Product Support Bulletin 2018-002

SUBJECT: HD TRIPP OVERHEAD CONSOLE GROUND

MACHINE MODEL(S): TRIPP HD

SERIAL NUMBER(S): 760700-760756, AND 761000-761002

P29-6 CONNECTOR

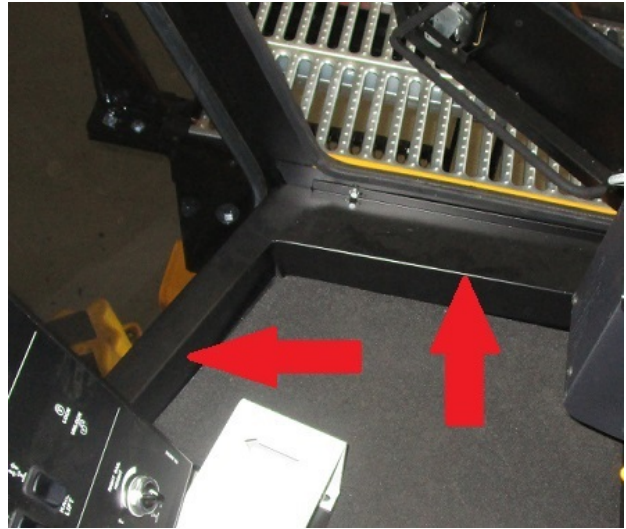
ACTION: A #4 AWG ground cable (P/N 87120146) with a crimped female socket on one end and ring lug on the other will need to be installed in the cab. First the raceway covers located below, along, and above the right door will need to be removed. Then the P29 connector located below the center console will need to be disconnected and have a crimped female socket of the cable inserted into the #6 position. Next run the cable through the raceways and into the overhead console with the ring lug being secured to the Ground stud in the overhead console. After installing the cable reconnect the P-29 connector and reinstalled the raceway covers. Allow 1 hours for installation. See page 2 for images
